# TECHNICAL EVALUATION REPORT

## REVIEW OF LICENSEES' RESOLUTION OF OUTSTANDING ISSUES FROM NRC EQUIPMENT ENVIRONMENTAL QUALIFICATION SAFETY EVALUATION REPORTS (F-11, B-60)

NORTHEAST NUCLEAR ENERGY COMPANY  
MILLSTONE NUCLEAR POWER PLANT UNIT 1

NRC DOCKET NO. 50-245

Figure A-5. Design Basis Accident Pressure as a Function of Time [FSAR]

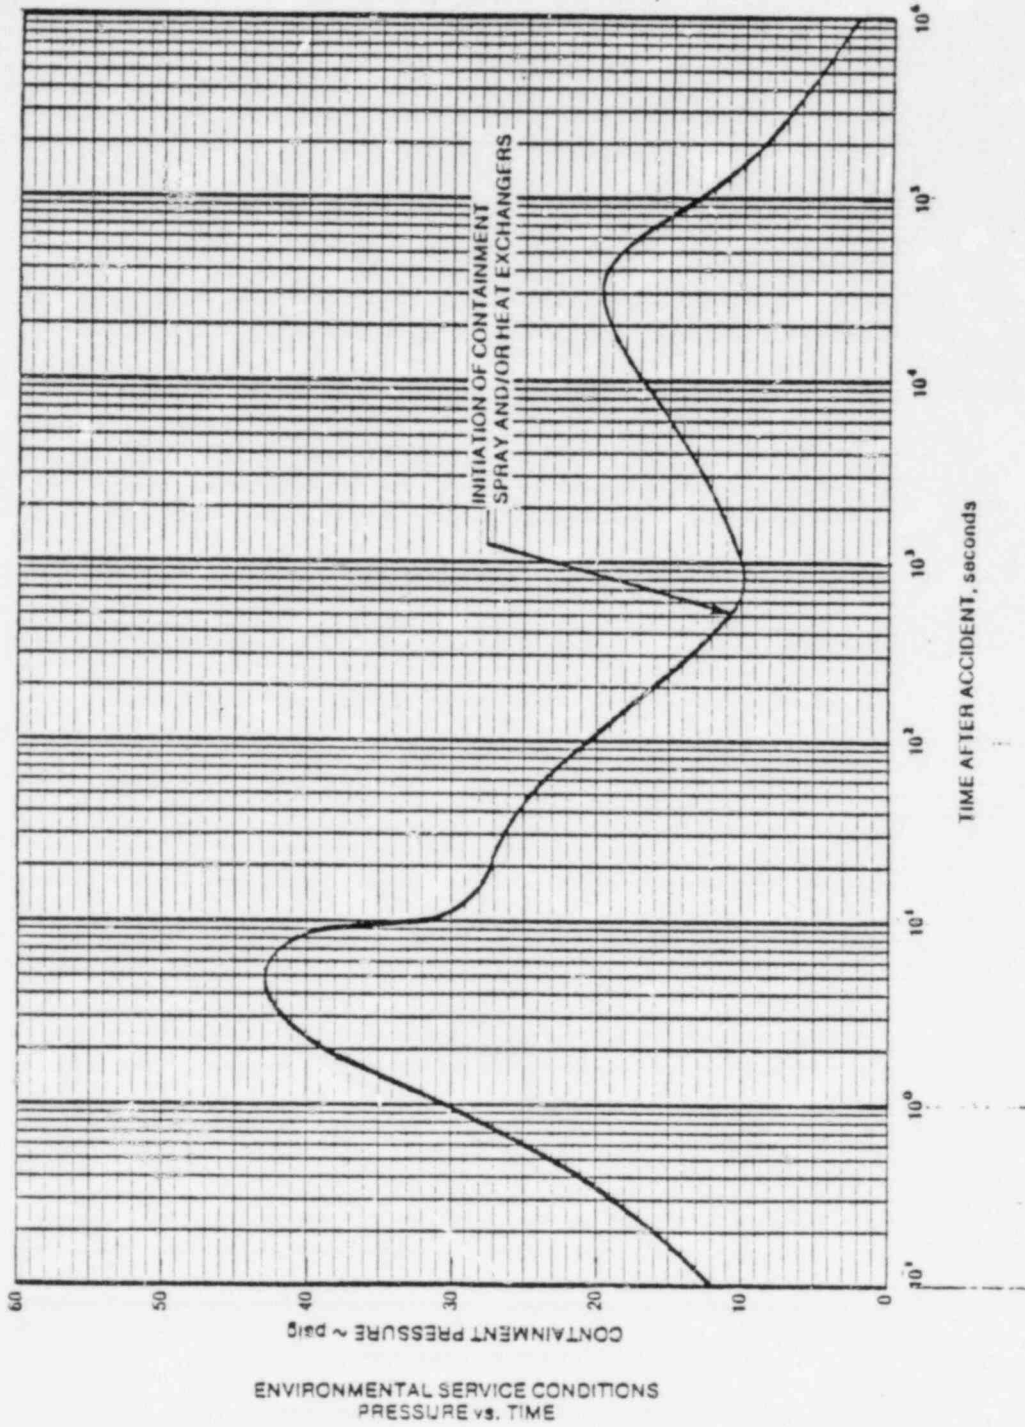
See Fig A-6?

Figure A-6. Design Basis Accident Pressure as a Function of Time [8]

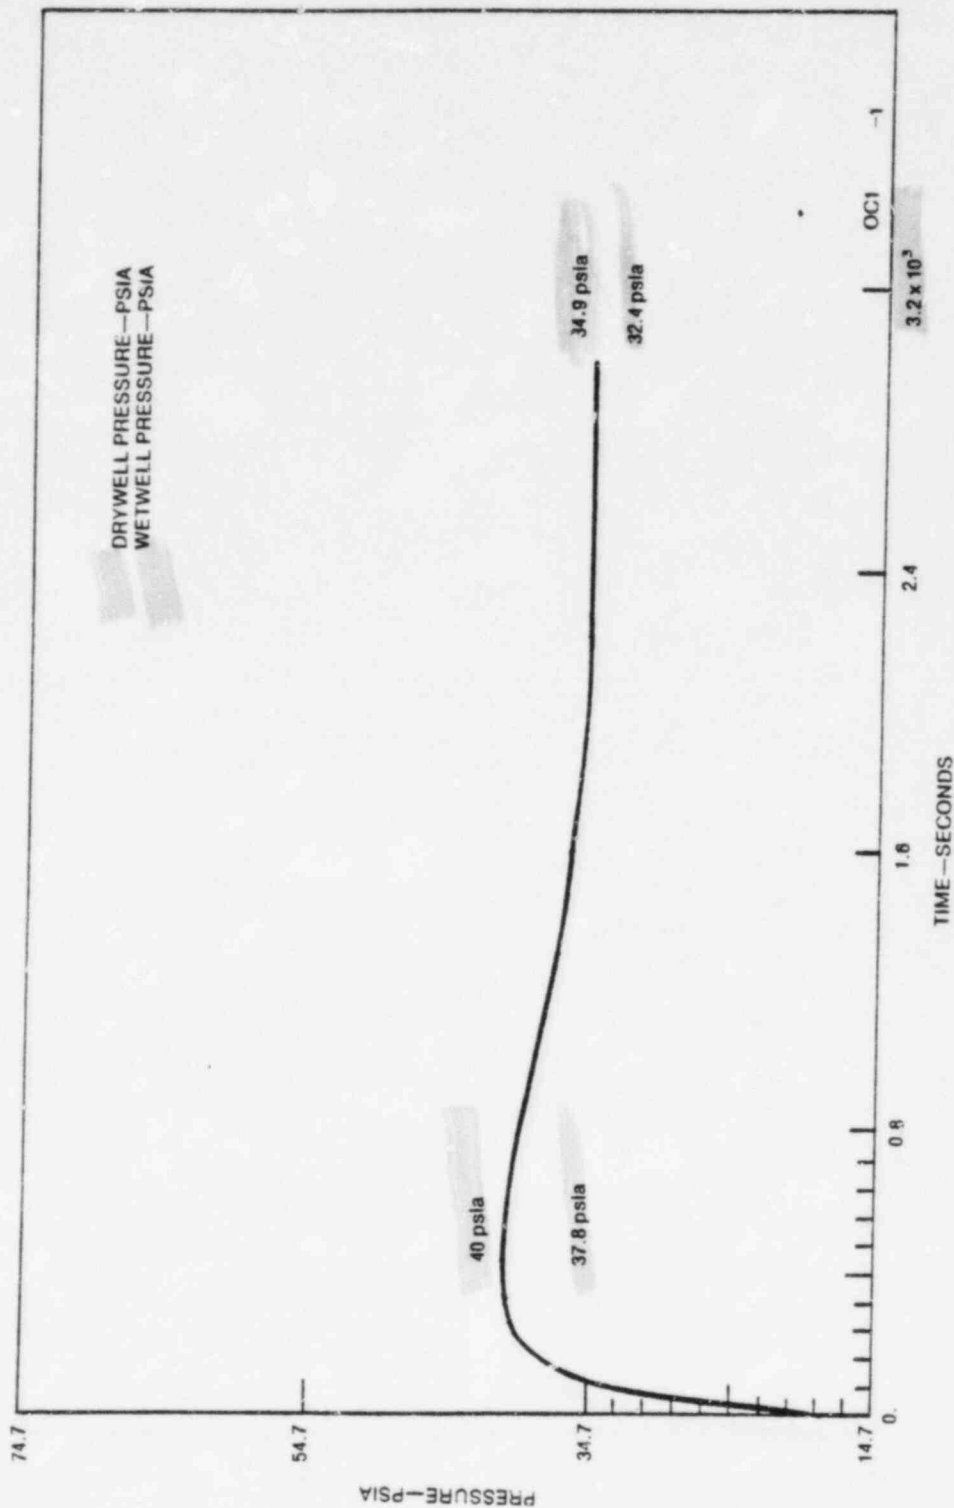
See A-5?

Figure A-22. Temperature Profile Corresponding to  $T_{sat} + 20^{\circ}F$  [42]

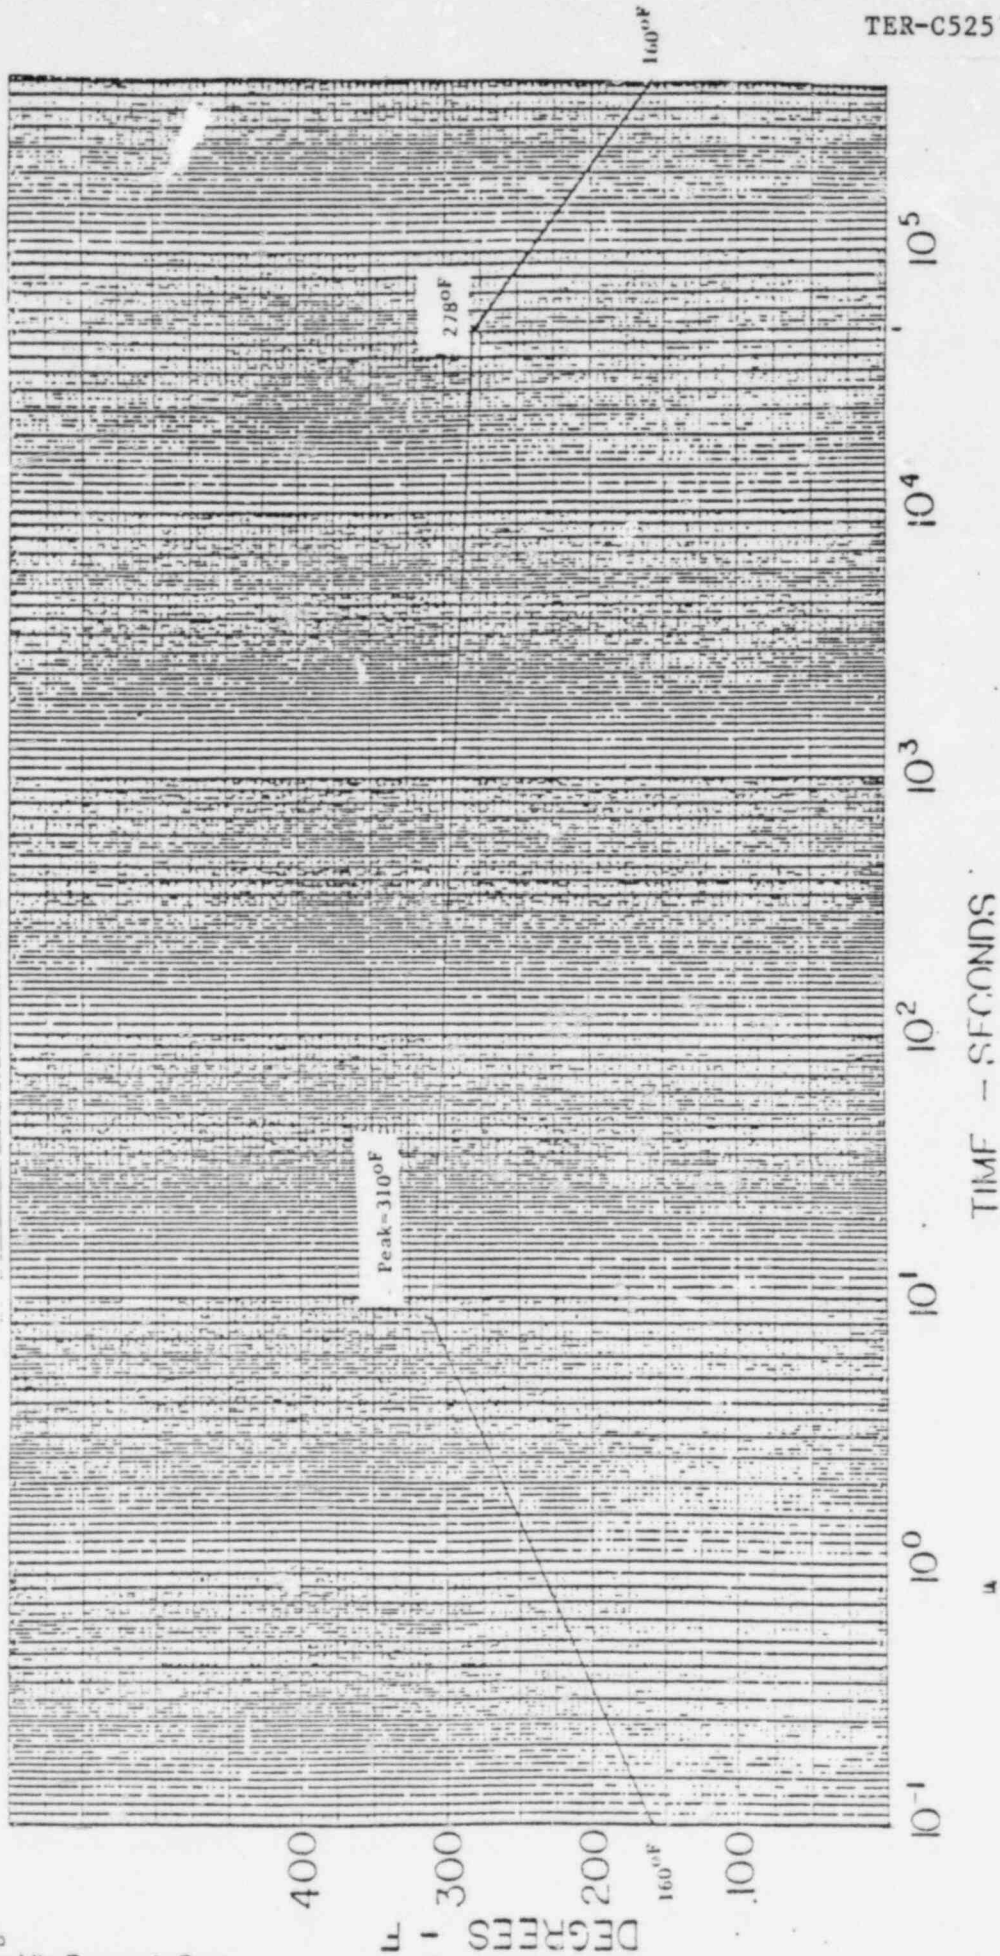
In Reference 22, the Licensee states that the environmental service conditions for temperature and pressure inside containment used on revised SCEW sheets are based on the peak temperature resulting from a MSLB (Figure A-4) and the peak pressure resulting from a LOCA (Figure A-5). In Reference 42, the Licensee states that some concern has been raised regarding the methodology employed to obtain the temperature profile shown in Figure A-4. The Licensee states that a revised profile has been developed based on a temperature 20°F higher than the saturation temperature associated with the peak drywell pressure for any design basis accident. The revised profile provided in Reference 42 is reproduced in this report as Figure A-22.
